Distribution: To all Team Leads and CCU System Engineers.	Document No.	WAG9-9K-EN5-RLN-13
	Issue Date.	11-Feb-2025
	Format	Total Pages : 5 + Enclosures: 2 Document initiated by : Sudhanshu Jha Initiating Department : RC-IN SMO RS EN 6 This supersedes : WAG9-9K-EN2-RLN-12

Release of CCU & TCU software.

Changes done in Ver. 2.08:

2) Loco Failed due to enabling the self-test mode reported from SCR/LGD: -

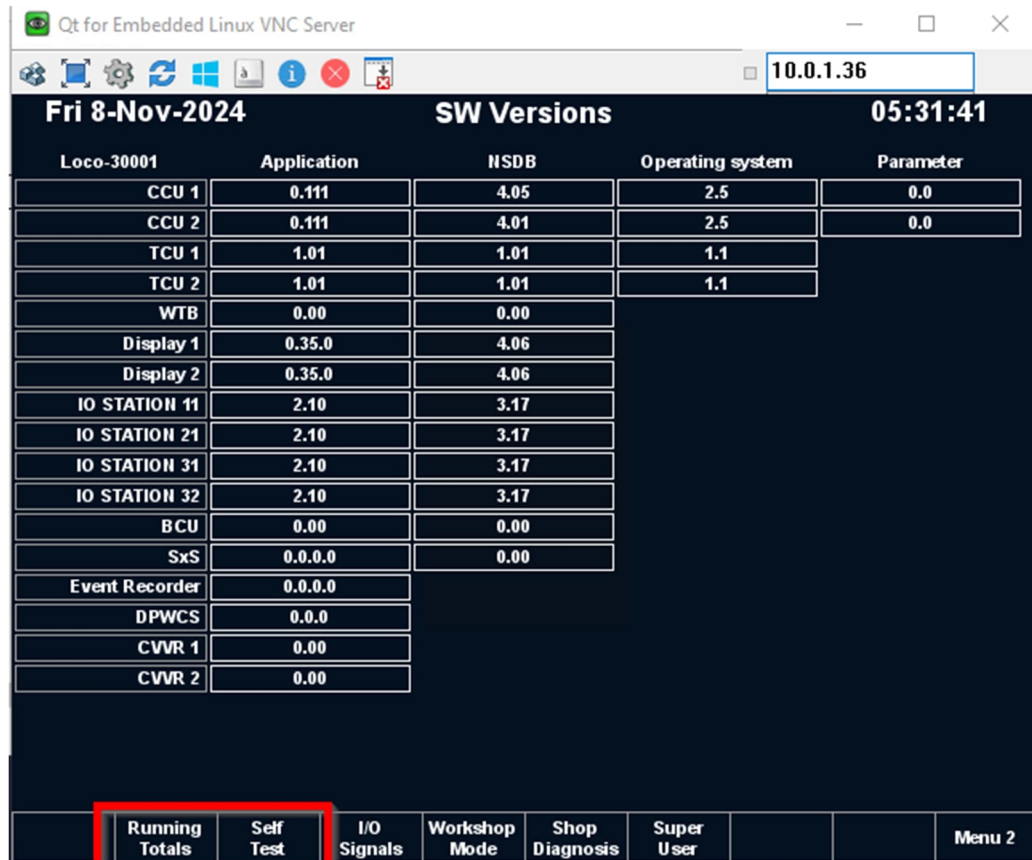
There were two failures reported from LGD/SCR regarding sudden pantograph lowering. On analysis of failure, it was observed from data that during the pantograph was lowered due to self-test enabling. As both Running totals and self-test activations are beside each other as shown below.

In new DDU software Location self-test function has been changed along with password protection enable.
